Columbia Precinct Stage 2

Urban Design Review

Prepared for
JQZ

Date
28 November 2019

Comparison of Pre-DA scheme (left) and current proposal (right) showing simplified façade and stepping of heights (image: MPA)

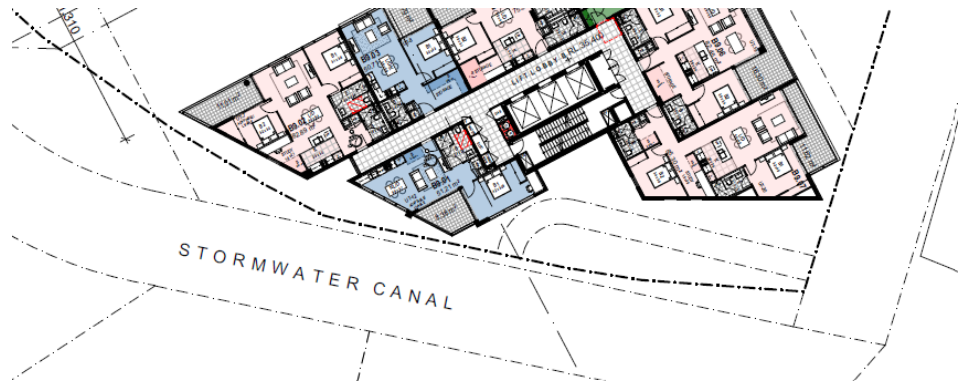
The façade appearance has been changed considerably in response to the comments made by Council. This is shown in the images below.

Key changes in the design addressing Council's advice have been to:

- reduce the 'over-articulation' and 'over provision of details' through simpler façade treatments
- emphasise verticality through vertical breaks in building forms and a change in design of the roof forms and stepped building heights

- reduce the length of the podium façade and breaking this up with clearer entries and visual permeability at ground floor where there was a comment noting this was 'without enough breaks'

- step the building heights (responding to 3(d)). This has only been partially possible whilst retaining compliance with the height of buildings control. Architectus agrees with the comment that transferring some of the building height from tower A to Tower B would result in a better outcome for views however understands that Council would not accept a variation in the height of building control to achieve this.

Image: Ground floor plans AP08 (above) and typical section through apartments and Nipper Street extension AP30 (below).

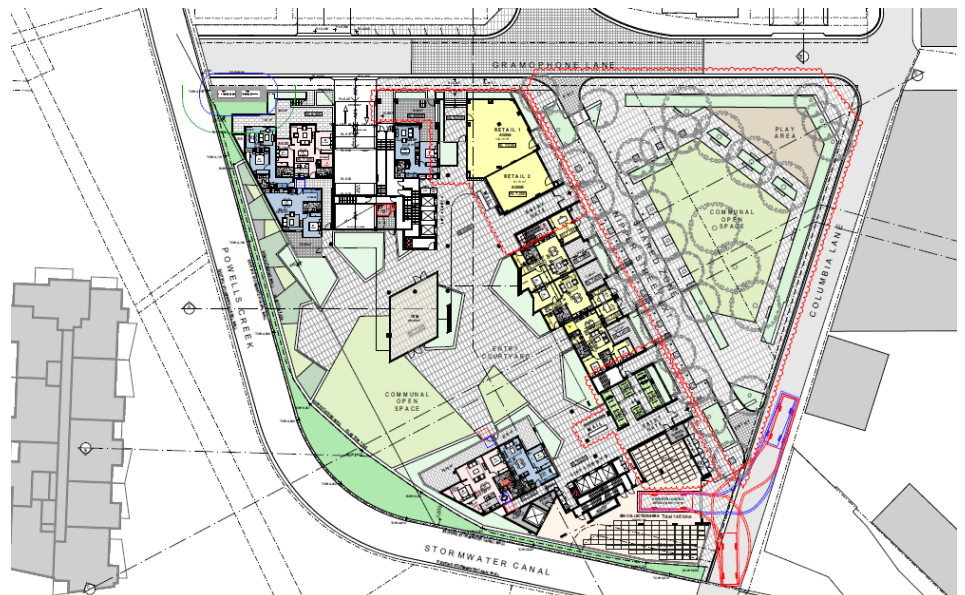
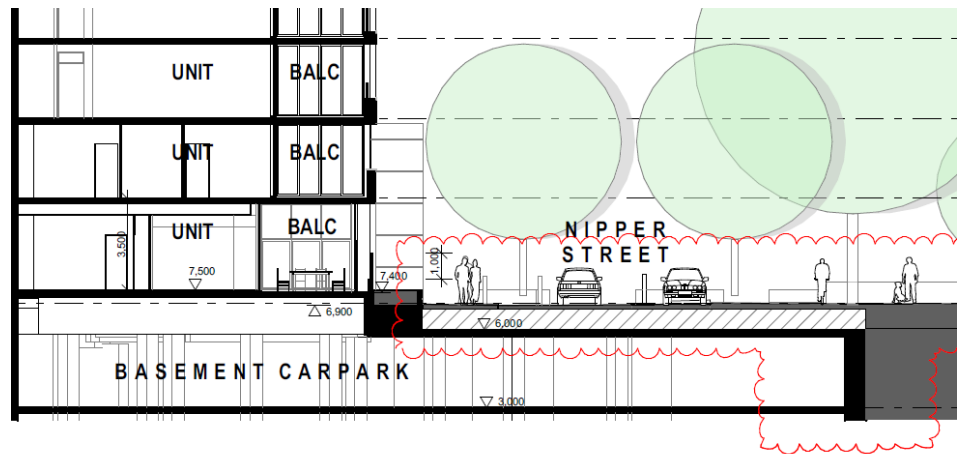
Comments have been provided on the relationship between units on Nipper Street extension. In the current proposal, Ground floor living areas facing the Nipper Street extension shared zone are generally 6m set back from the pedestrian area of the shared zone (including a 2m planted buffer plus a 4m private open space behind). The units are live-work units and the office components benefit from level street access. Architectus considers this an appropriate relationship to Nipper Street. This is further described on the plan and section below.
